**STATE OF DELAWARE
EXECUTIVE DEPARTMENT
OFFICE OF STATE PLANNING COORDINATION**

October 22, 2014

RE: PLUS review 2014-09-05, Caesar Rodney School District New Elementary School

Figure 1: NRCS soil survey mapping update in the vicinity of the proposed project

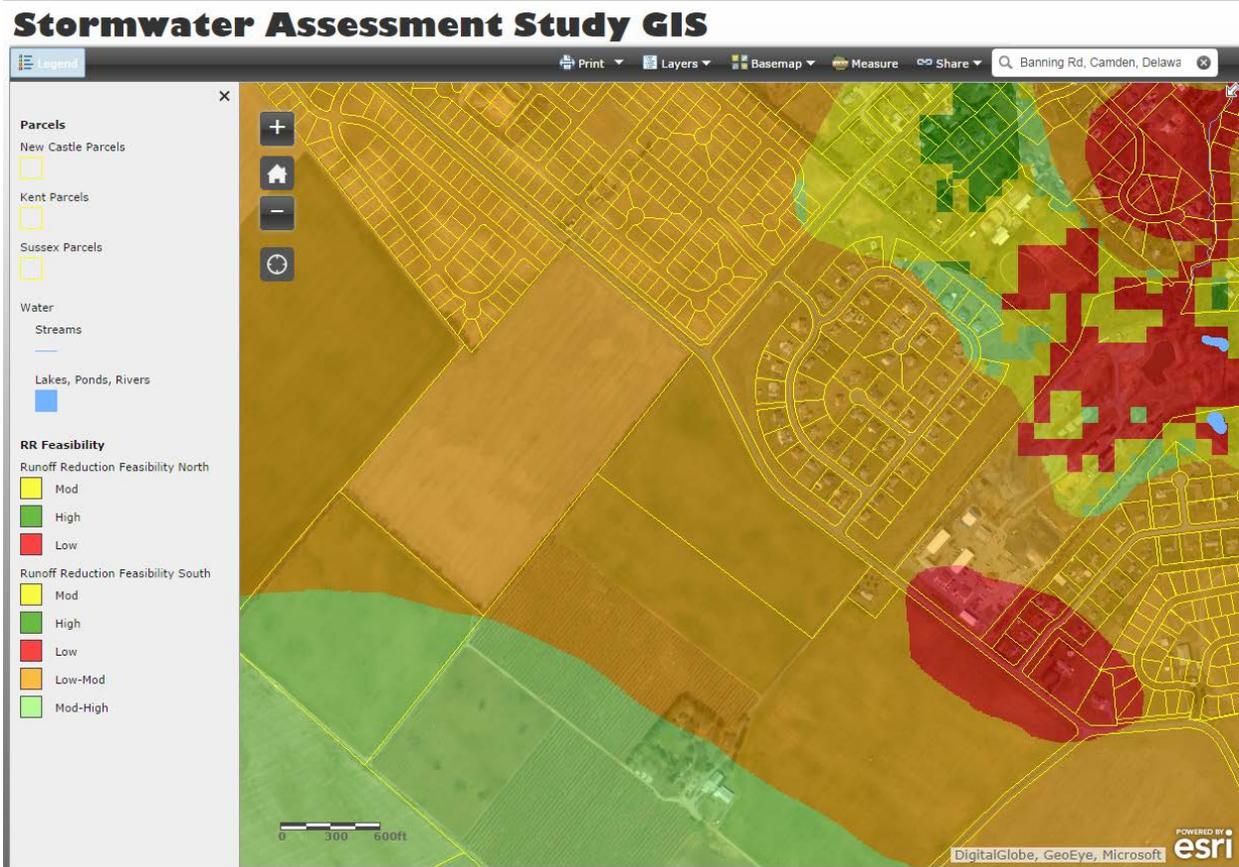
- Based on soils survey mapping update, the soil mapping unit(s) mapped is Downer. This soil mapping unit is well drained and, in general, has few limitations for development.
